STARBUCKS COFFEE COMPANY
PORTION OF PARCEL 1-A, TRACT BB
MONARCH VILLAGE CONT 0.5785 ACRES
CITY OF ALBUQUERQUE, COUNTY OF BERNALILLO, STATE OF NEW MEXICO
SITE CONSTRUCTION PLAN

63433-001
STARBUCKS DRIVE-THRU
700 JUAN TABO NE
ALBUQUERQUE, NM 87123

SHEET TITLE:
GRADING & DRAINAGE PLAN
AS-BUILT
SHEET NUMBER:
C301

SHEET TITLE:
GRADING & DRAINAGE PLAN

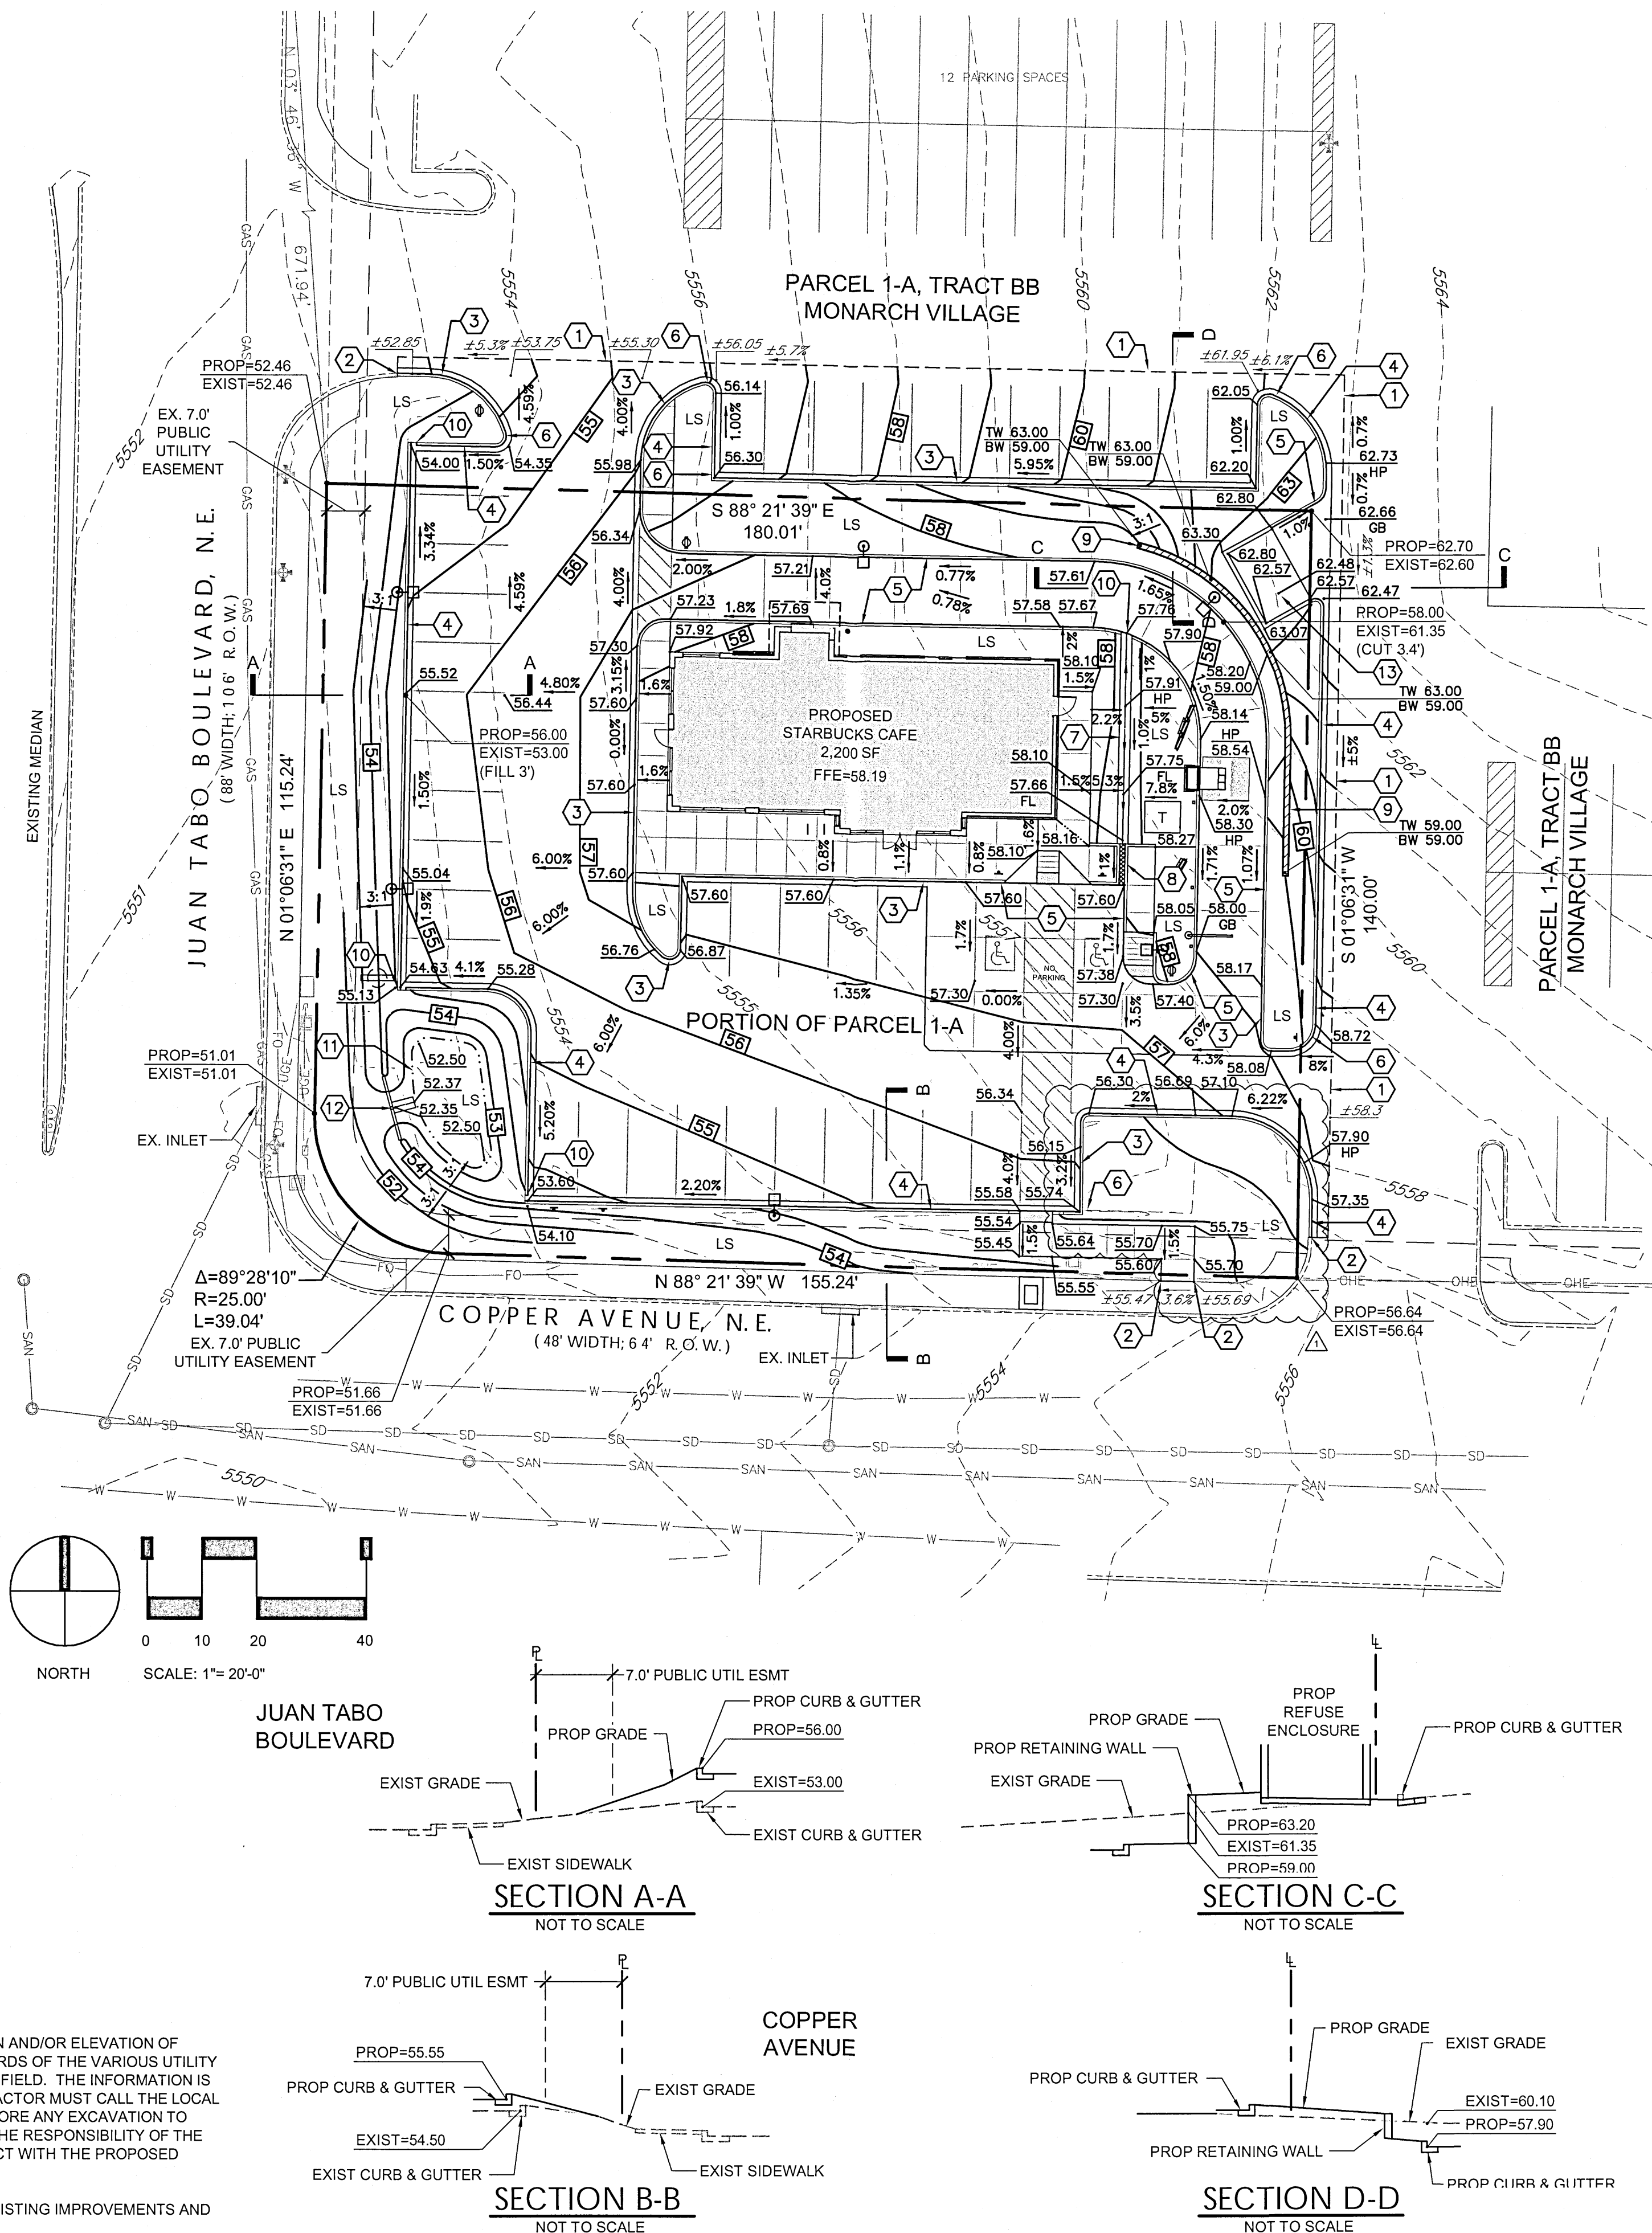
From my review of the photos, it appears the 2-foot wide concrete valley pan to be located between the proposed building and drive-through lane entry has been constructed. The photos also indicate construction of the sidewalk culvert associated with this pan. In addition, the photos indicate one of the four curb openings (at the far southwest corner of the site) to have been constructed.

Based on this review of the photographs provided, and of this information only, it appears the improvements listed herein have been located in general conformance with the approved plan(s).
